1984 Corvette: Service Bulletin: Engine Stops Running When Starting with Air Conditioning "On"

Subject: Engine Stops Running When Starting with Air Conditioning "On"
Model and Year: 1984 Corvette with Automatic Transmissions
Source: Chevrolet Dealer Service Bulletin
Bulletin No: 84-240
Section: 8B (XII)
Date: Feb. 1985

**A/C CLUTCH ON REVISED ECM SIGNAL
INPUT BLOCK DIAGRAM**

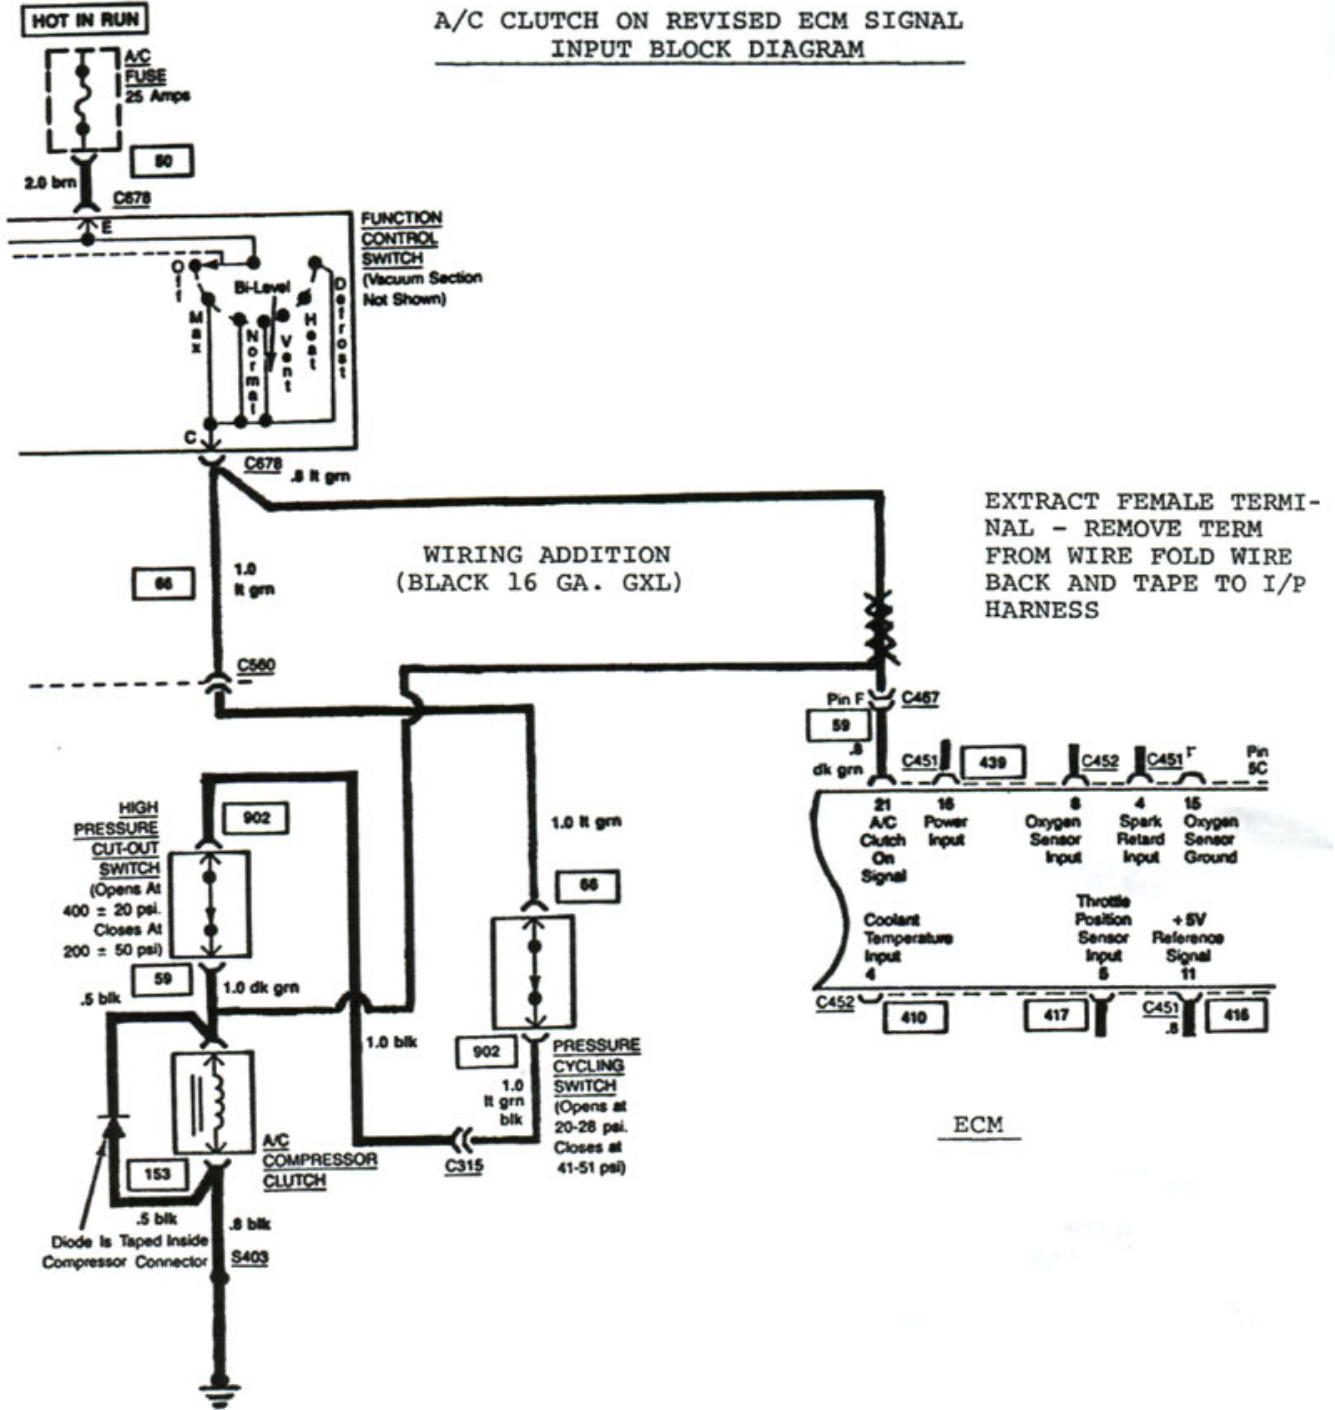
This revision requires installing a 16 Ga. wire into the A/C discrete circuit at connector C-467, Pin F of the I/P to ECM harness, routing the wire through the bulk head connector and splicing into the A/C circuit of the engine, between the pressure cycling switch and the compressor clutch (see block diagram).

FIGURE 1

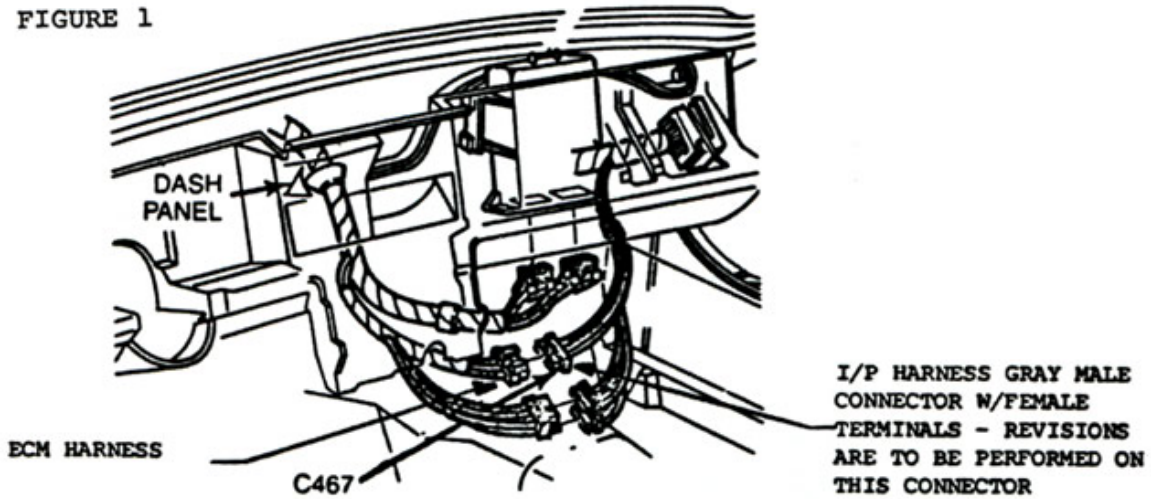
1. Remove I/P upper trim pad assembly. Remove L.H. and R.H. hush panels.
2. Extract female terminal (green wire) from gray I/P to ECM harness connector C-467, circuit 66 (see Figure 1.)
3. Cut off and discard extracted female terminal. Fold severed green wire back and tape it to the I/P harness, making sure the severed wire end is well insulated with electrical tape.
4. Utilize the 22 feet of 16 Ga. GXL black wire by stripping one end and crimping, P/N 12015856, female terminal on the stripped end. Insert the new terminal into connector C-467, Pin F.

FIGURE 2

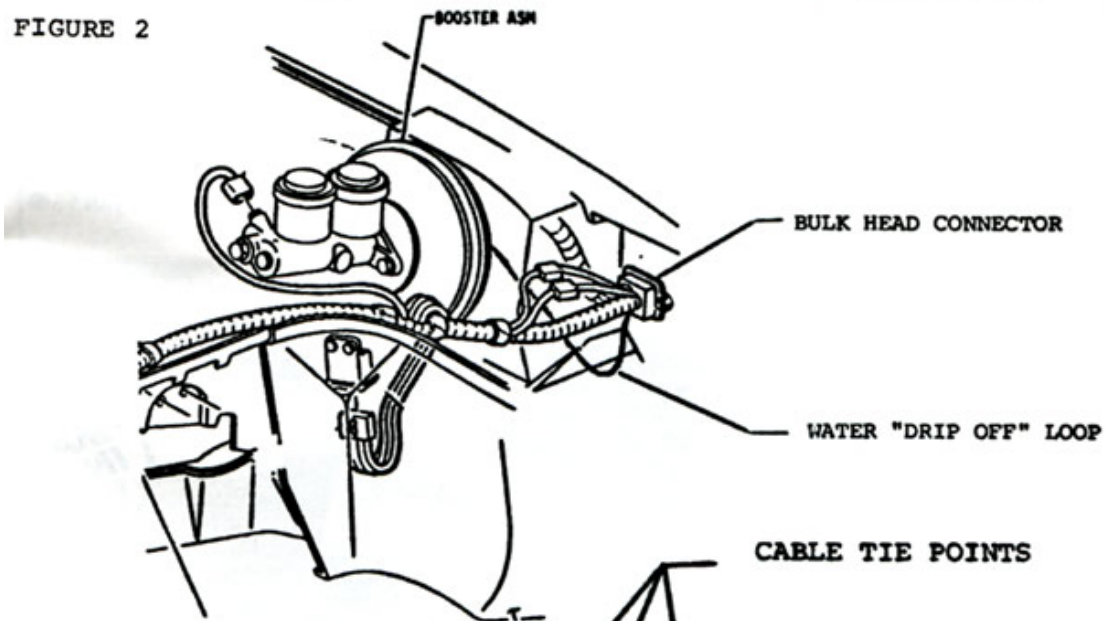
6. Using masking tape, secure the signal wire to the A/C ducts to avoid wire abrasion and rattles.
7. Remove I/P harness bulk head caps on the passenger compartment side, as well as the engine compartment side. DO NOT disconnect the bulk head connectors.
8. Feed the signal wire through the open (unused) bulk head, Pin #E4, located adjacent to a 12 Ga. red wire. it may be necessary to strip the feed end of the signal wire approximately two (2) inches from the end and "solder tint" the wire to aid in guiding the wire through the bulk

FIGURE 3

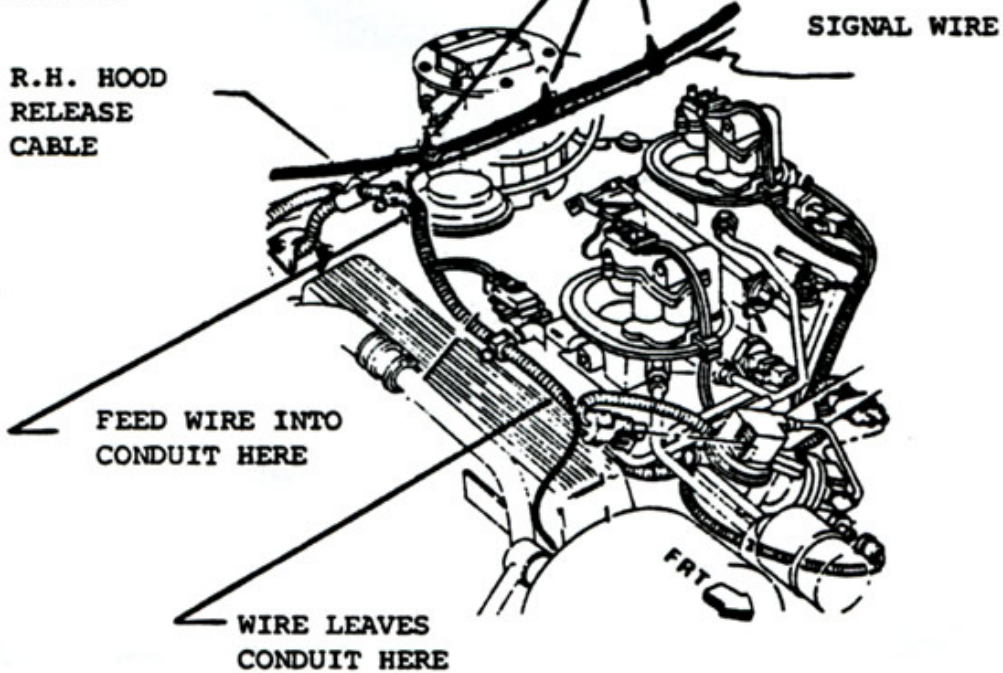
9. Once the signal wire has been fed through the bulk head connector, grease is to be packed around the signal wire at both sides of the connector. This step assures an adequate bulk head connector to signal wire seal.
10. Reinstall the bulk head harness caps.
11. Loop the signal wire down below the bulk head connector and back up behind the brake booster (see Figure 2.)
12. Route the signal wire along the R.H. hood release cable securing the wire to the cable with three (3) cable ties.
13. At the R.H. rear corner of the engine, direct the wire to the front of the engine and install it in the existing engine harness conduit (see Figure 3.)

FIGURE 4

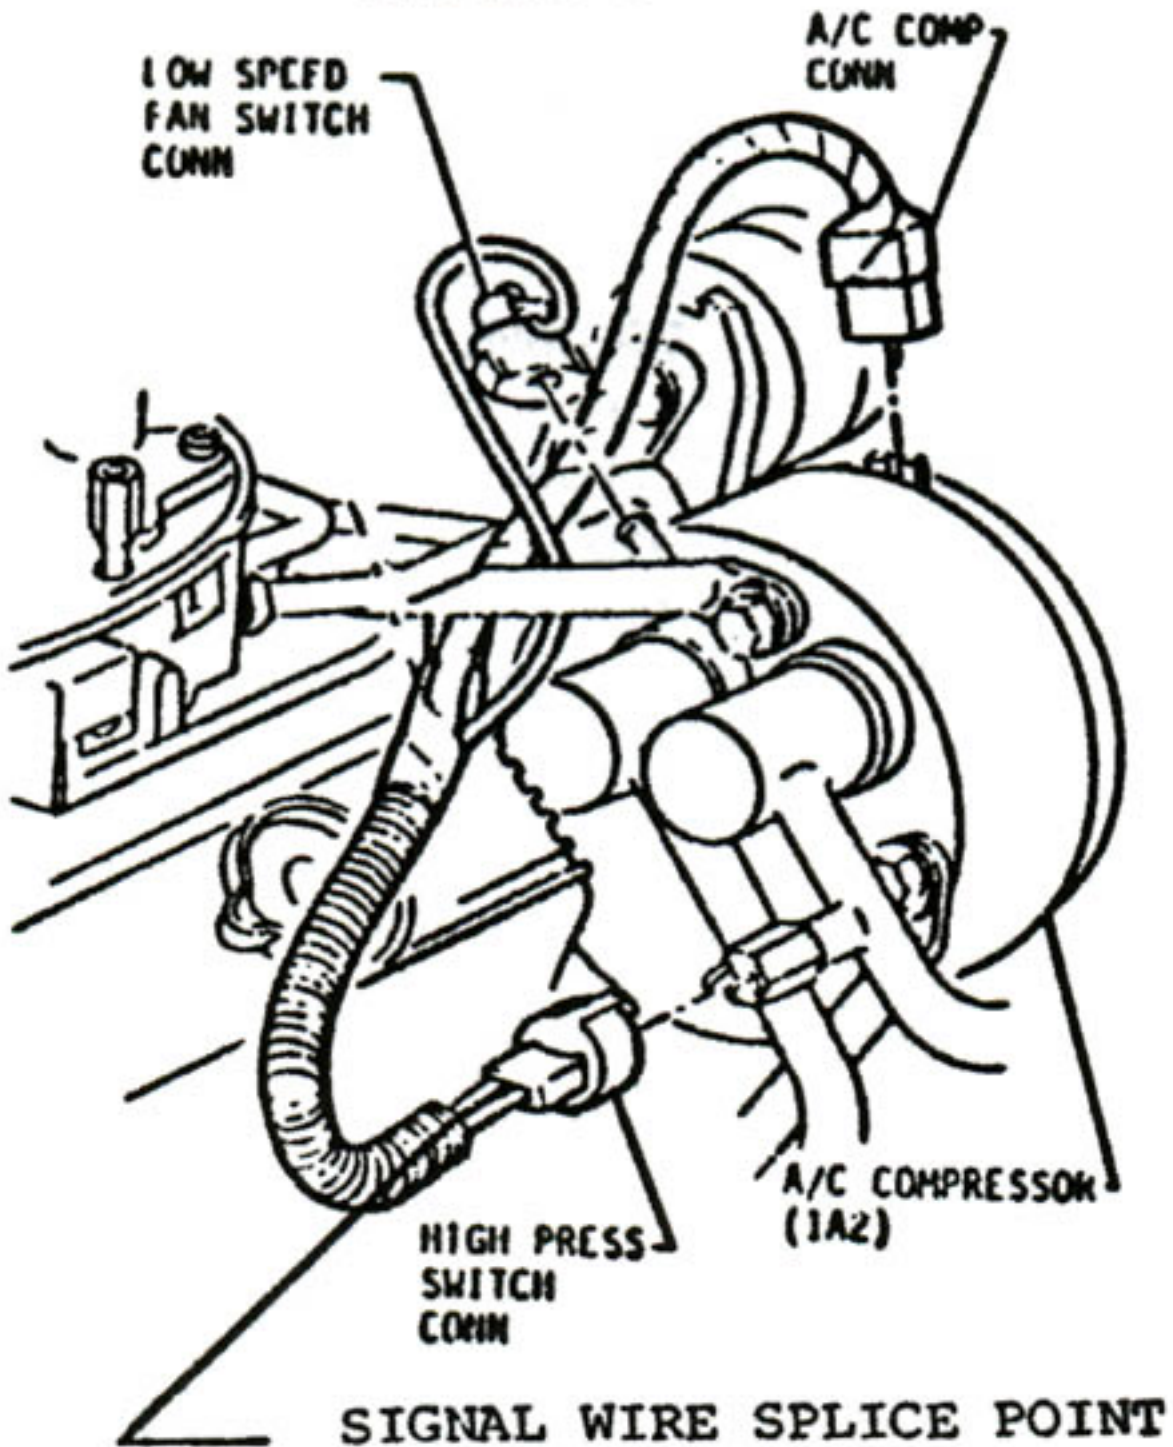
14. Remove the harness end tape and strip the insulation back .5 inches on the green wire at the high pressure A/C switch connector (see Figure 4.)
15. Remove excess signal wire length, if necessary, and strip end back .75 inches. Wrap the signal wire around the A/C clutch green wire and solder to insure a good connection.
16. Retape harness at high pressure switch connector.
17. Reinstall I/P upper trim panel and hush panels.
